# Work Order ID 92561

Item ID: 647.1713 Accept \*N900040100\* Setup Start \*NS1\*  
 Revision ID: Stop \*NS2\*  
 Item Name: Spacer  
 Start Date: 11/05/12 Start Qty: 2.00 \*2\* Cust Item ID:  
 Required Date: 11/12/12 Req'd Qty: 2.00 \*2\* Customer:  
 Reference:

ENGINEERING CHANGE NOTICE NO.		02937		SHEET 1 OF 1	
DWG NO. 647.1700	REV: NC	PREPARED BY J. JACKSON	DATE: 07/14/10	EFFECT ON DWG: <input type="checkbox"/> INC. <input checked="" type="checkbox"/> UNINC.	
DWG TITLE: SKID DEFLECTOR ASSY					
APPROVED BY: ENGR <i>[Signature]</i>	MFG <i>[Signature]</i>	OR <i>[Signature]</i>	EFF: CURRENT ORDER		
REASON: REVISED F/N 8 AND NOTE 3. ADDED INSPECTION DIMENSIONS TO DRAWING VIEWS.

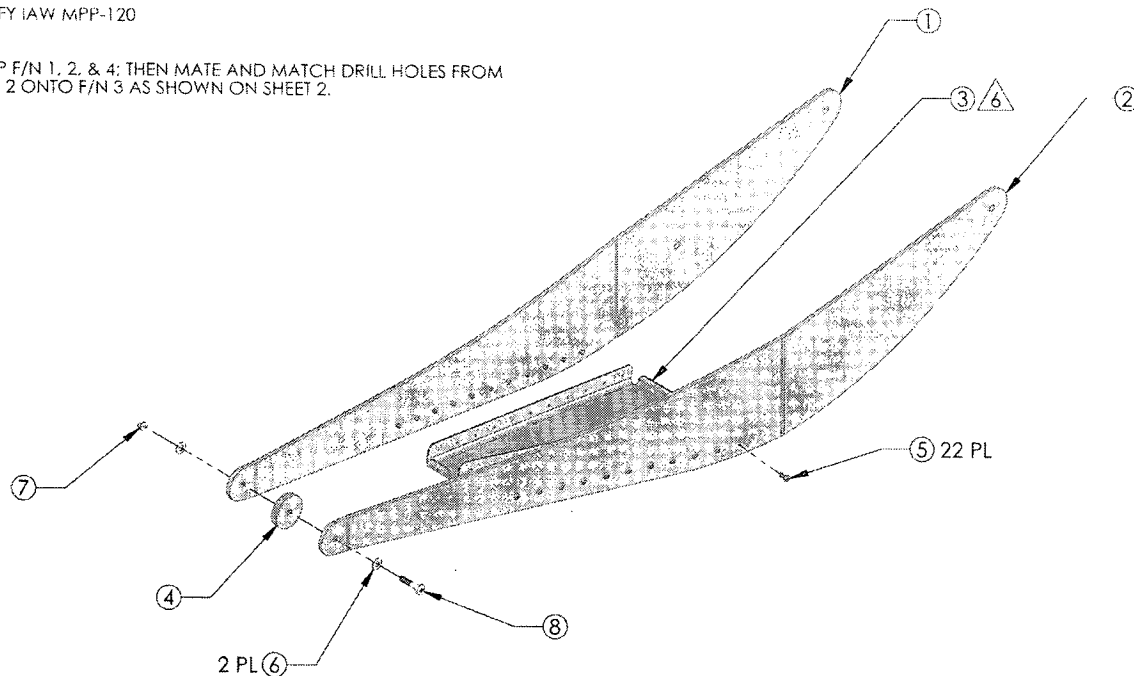
SHEET 1, ZONE A1 IS:

3 FINISH: HARD ANODIZE IAW MIL-A-8625 TYPE III CLASS 2, COLOR BLACK;  
PRETREAT PRC-DESOTO PR-148 ADHESION PROMOTER, COLOR BLUE;  
PRIME IAW MIL-P-23377J TYPE I CLASS N

- 1 MATERIAL: 7075-T6 ALUMINUM PER AMS-QQ-A-250/12
- 2 MATERIAL: 6061-T6 ALUMINUM BAR IAW AMS-QQ-A-250/11
- 3 FINISH: HARD ANODIZE IAW MIL-A-8625 TYPE III CLASS 2, COLOR BLACK; CARDINAL 4860-50 PRETREATMENT PRIMER; PRIME IAW MIL-P-23377J TYPE I CLASS N
- 4 DEBURR AND BREAK ALL SHARP EDGES
- 5 IDENTIFY IAW MPP-120
- 6 CLAMP F/N 1, 2, & 4; THEN MATE AND MATCH DRILL HOLES FROM F/N 1 & 2 ONTO F/N 3 AS SHOWN ON SHEET 2.
